# PLANNING COMMISSION MEETING

**File Number 2018-40-CUP**

Zaloznik Duplexes (NE 202<sup>nd</sup> and NE Oregon – Esther Estate Subdivision)  
Type III Quasi-Judicial Procedure

**PLANNING COMMISSION STAFF REPORT  
TYPE III SITE CONDITIONAL USE PERMIT  
FINDINGS AND STAFF RECOMMENDATION**

**FRONT ELEVATION**  
1/4" = 1'-0"

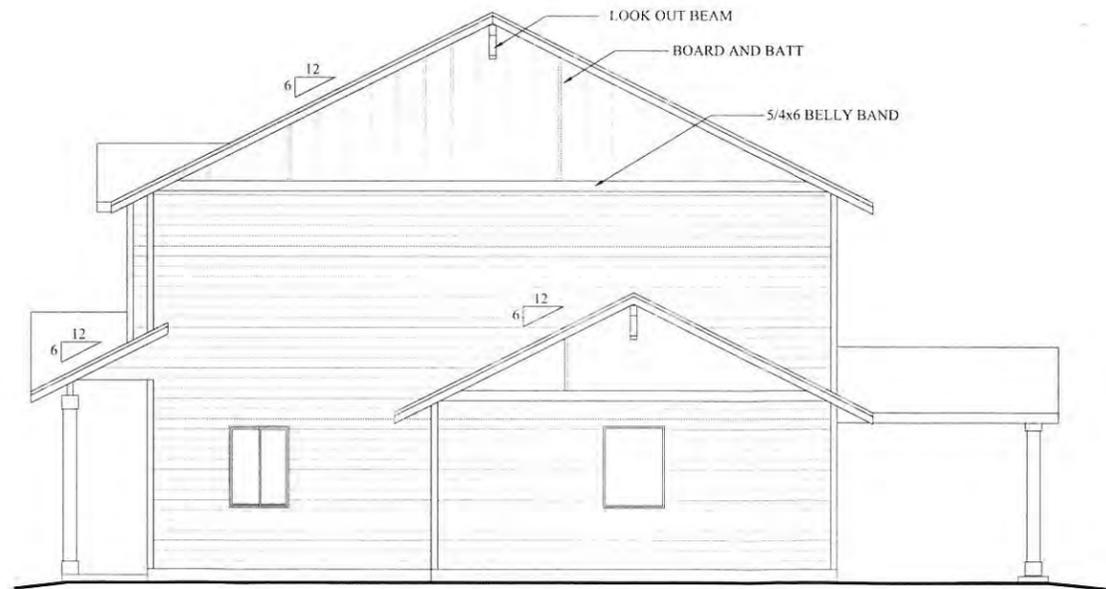
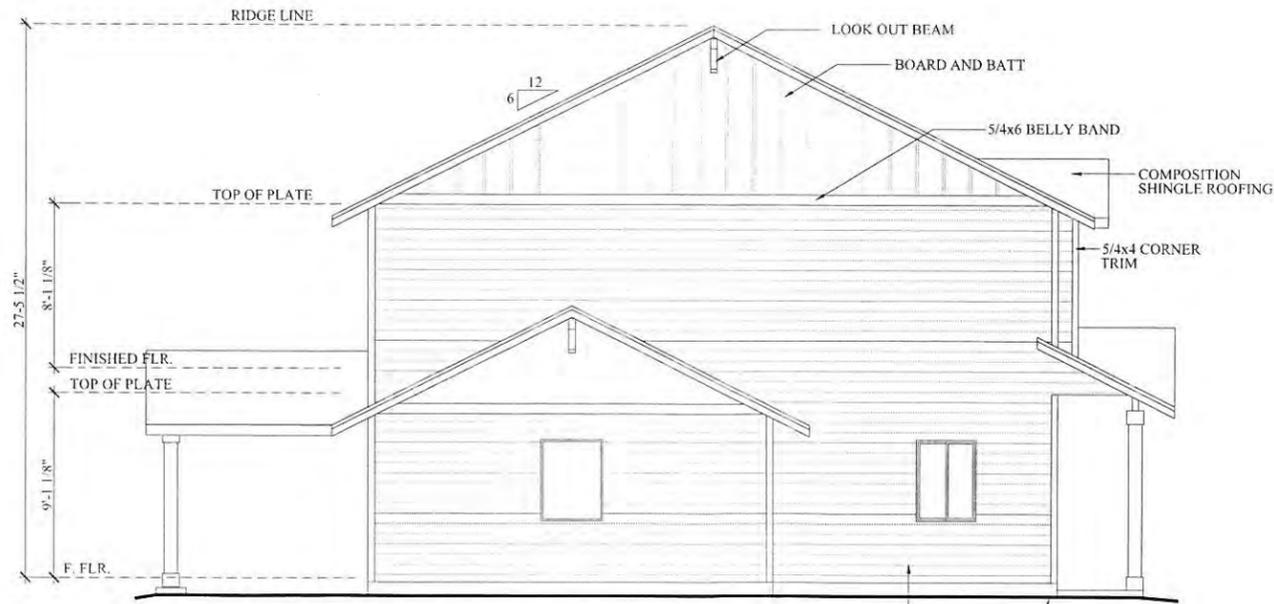
**Condition of Approval:** Prior to building plan review, the applicant shall submit revised building elevations that show the rear wall (top/bottom floors) and side walls (top/bottom floors) for the duplex on Lot 3 comply with the building form standard above.

Prior to building plan review, the applicant shall submit revised building elevations that show the rear wall (top/bottom floors) and side walls (top/bottom floors) for the duplex on Lot 4 comply with the building form standard above.

**Condition of Approval:** Prior to building plan review, the applicant shall submit revised elevations that show the rear wall for the duplexes on Lots 3 & 4 comply with the detailed design standards above.
